OAM for 802.3cg 10BASE-T1S

Jay Cordaro & Mehmet Tazebay

147.3.8 Operations, Administration, and Maintenance (OAM)

Figure 147-x CRC6

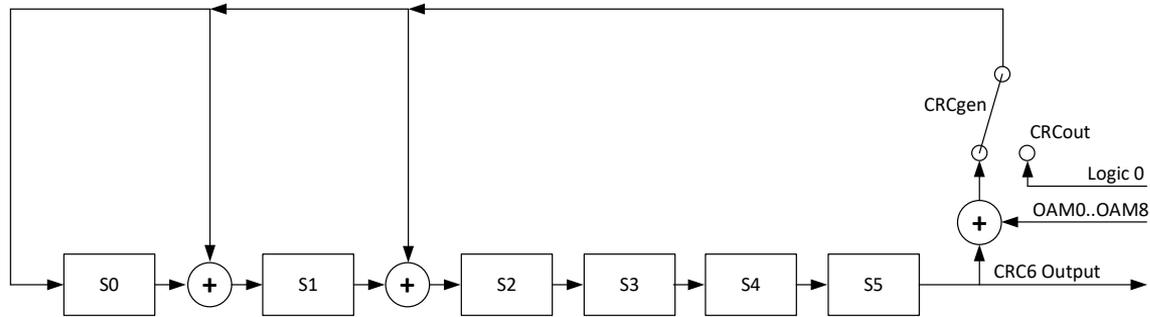
The CRC6 implements the polynomial x^6+x^2+x+1 of the previous 9 bits. The CRC6 shall produce the same result as the implementation shown in figure 147-xx. The 6 delay elements S0,...,S5 shall be initialized to zero. Afterwards the 9 data bits are used to compute the CRC6 with the switch connected (setting CRCgen). After all 9 data bits have been processed, the switch is disconnected (setting CRCOut) and the 6 values stored in the delay elements are ordered as illustrated, first S5 followed by S4, then S3, S2, S1 and the final value S0.
